Additional Traffic and Access Report

18 October, 2013

**RE: PART 3A APPLICATIONS FOR PROPOSED NEPEAN GREEN AND
MASTERS MIXED USE DEVELOPMENT, 164 STATION STREET, PENRITH**

**19m ARTICULATED TRUCK
 SWEPT PATHS**

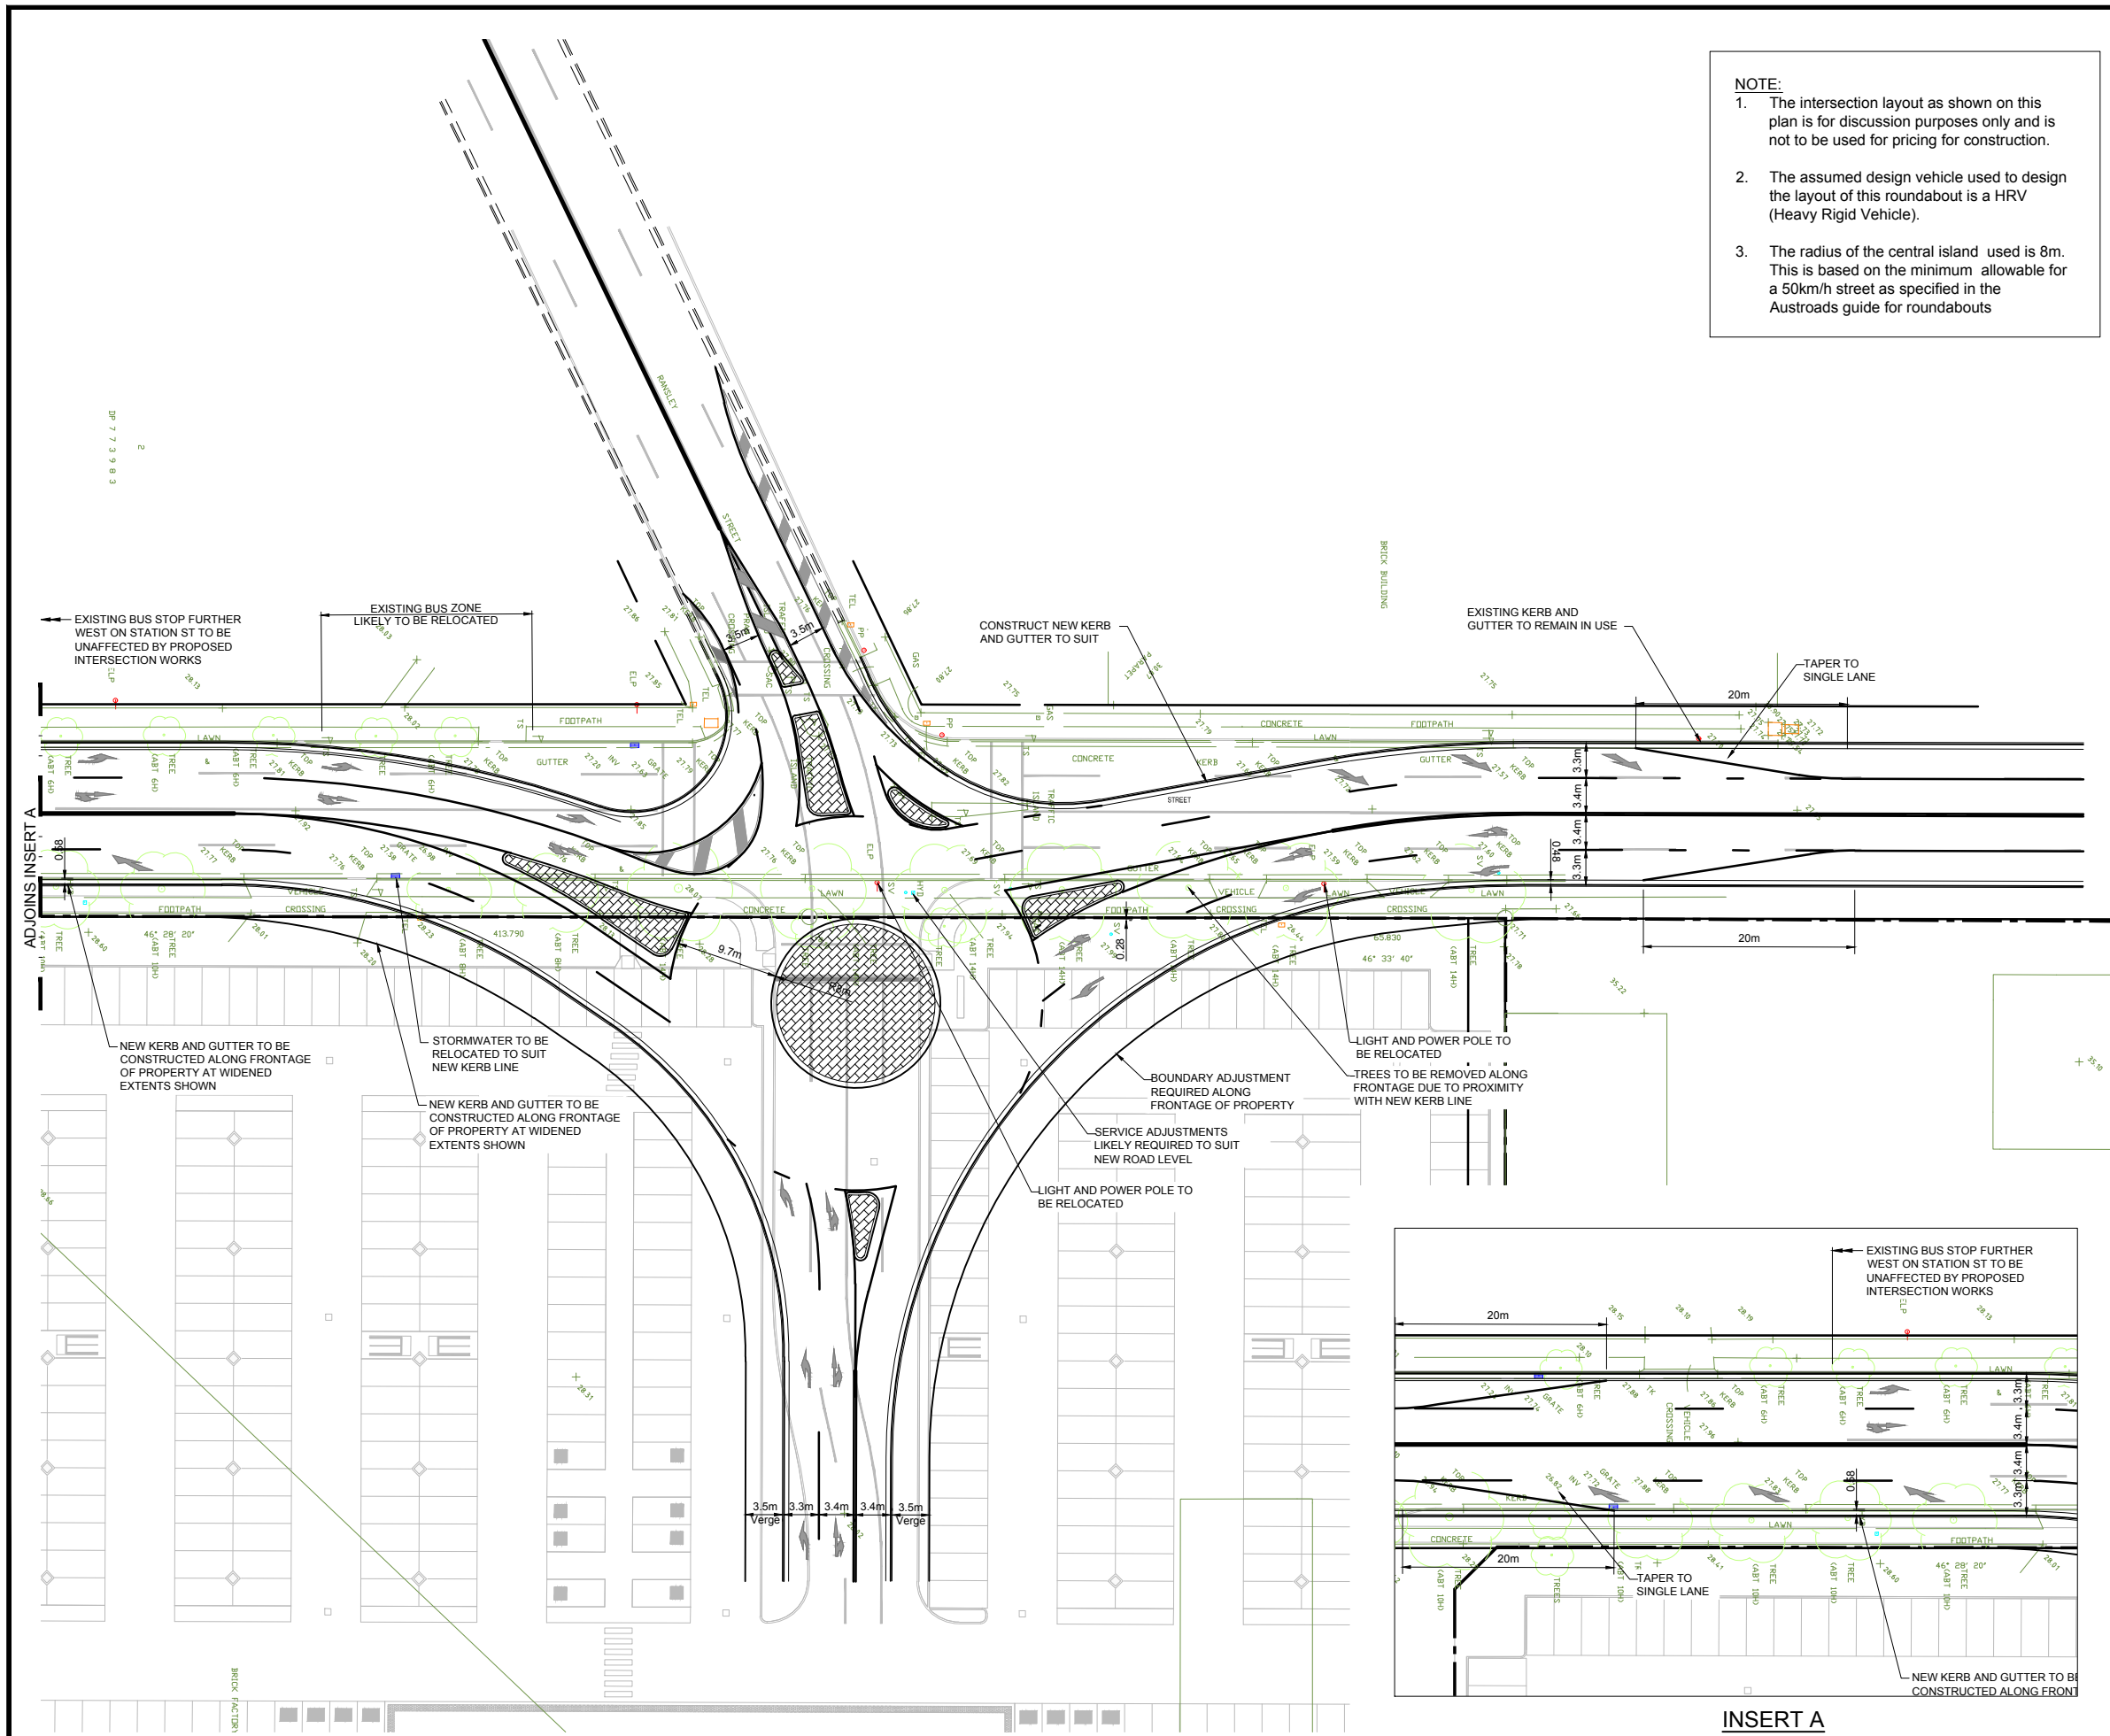
- a) *Swept paths have not been shown for the reverse loading movements on the southern side of the loading area (adjacent to the new central access road and to the rear of the trade centre).*

- b) *The reverse movement on the northern side of the loading area appears to show vehicles encroaching outside the gate at the exit driveway, to enable reversing into the loading dock. Clarification is required as to whether this will occur, and whether this reversing movement will result in any safety issues for pedestrians in Woodriff Street which needs to be addressed.*

30. The loading area on the eastern side of the Masters store has been amended. Swept paths are attached to this letter as Figures 4 and 5.
- c) *The swept paths diagrams should show traffic lanes on Woodriff Street as well as the proposed road (the new street) to determine whether these turn movements encroach across the centrelines of the roads.*
Parking restrictions may be required along Woodriff Street, on either side of the driveway access points, to cater for the swept paths of longer vehicles turning into and out of the site, so as to avoid them crossing the Woodriff Street centreline. Also, right-turn in and left-turn in movements off Woodriff Street appear to cross over the centreline area of the proposed road (the new street), which is undesirable and sub-standard for the main loading access point.

31. The amended loading dock for Masters provides for vehicles to enter and exit on the left hand side of the road, as shown in Figures 4 and 5.
- d) *It is unclear how conflicts would be managed resulting from longer vehicles turning from Woodriff Street needing to wait for any vehicles exiting and turning out of the site and the proposed road.*

Nepean Green Penrith
Infrastructure Sketch
Concept Intersection Design
Station Street and Ransley Road
Roundabout Option

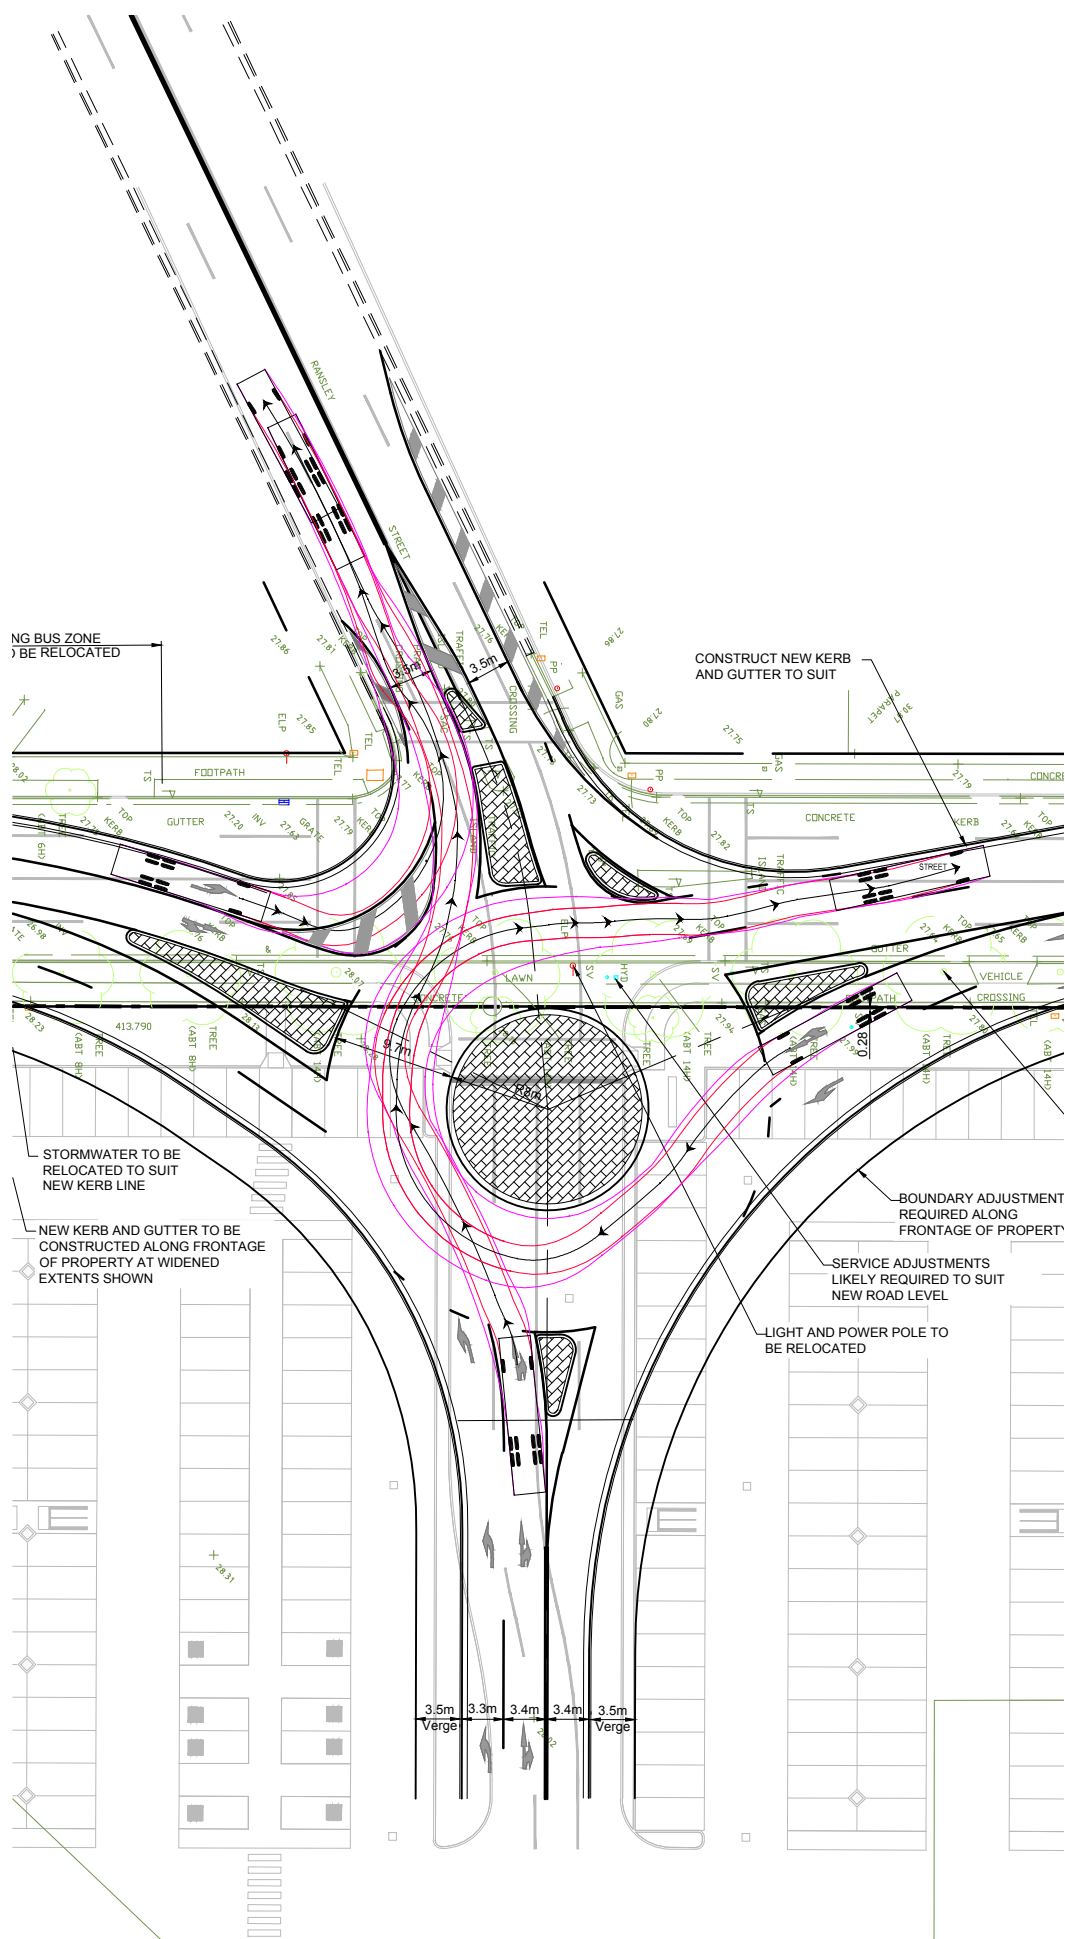
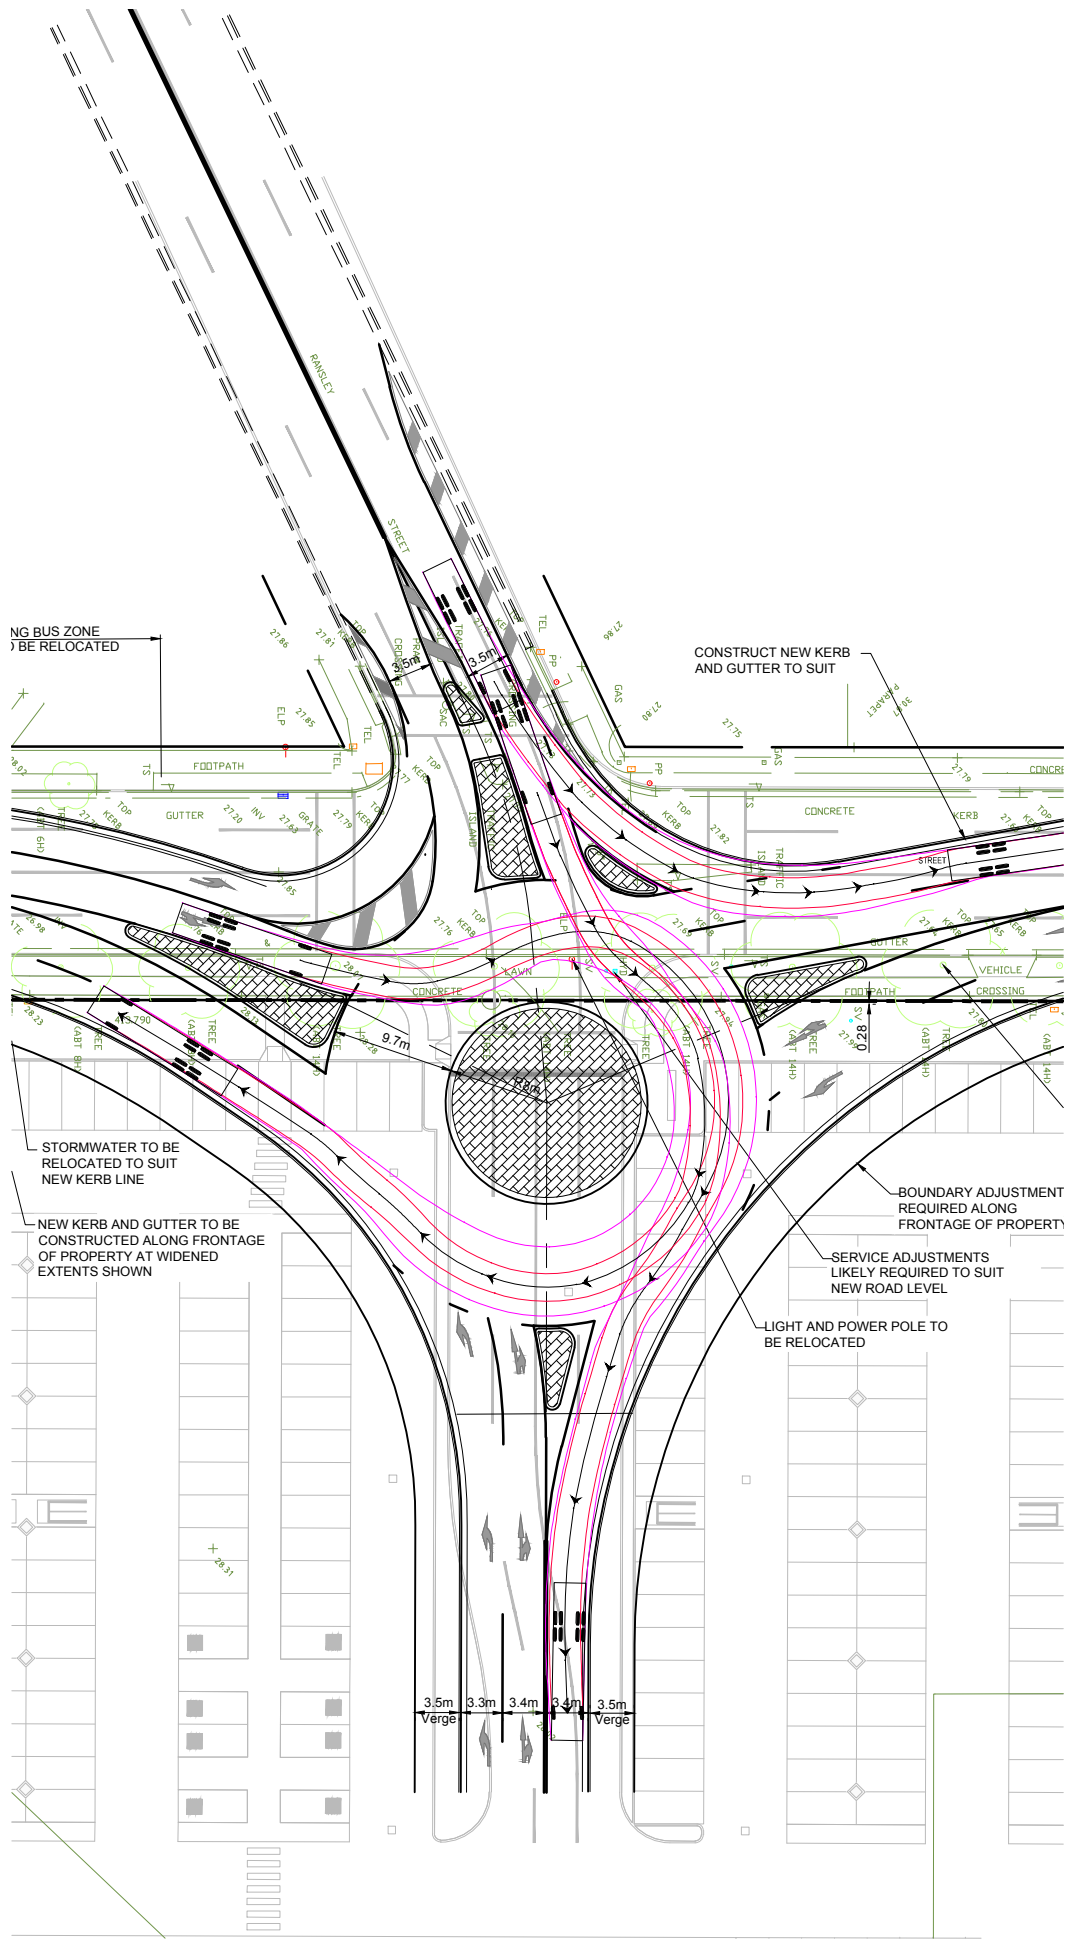
"Analysis with SIDRA indicates that sign controls would not have the capacity to cater for traffic flows through the intersection. A roundabout would not be practicable as it cannot be provided within the available space."

RMS requests that the applicant justifies the above statement by submitting the analysis which was carried out for the alternative options, particularly for the roundabout option.

36. In relation to the warrants for traffic signals, we have had a meeting with RMS and understand that RMS is reviewing its interpretation of an 'average' day.
37. With regards to the potential for a roundabout at the intersection, copies of a concept drawing for a roundabout at the access point are attached to this letter. As shown in the drawing, there is not space available in Station Street to provide the deflection required on the Station Street approaches, and appropriately accommodate turning vehicles.
38. As also noted in our previous letter of 26 July, a roundabout would also not cater as well for pedestrians at the intersection, compared to traffic signals.
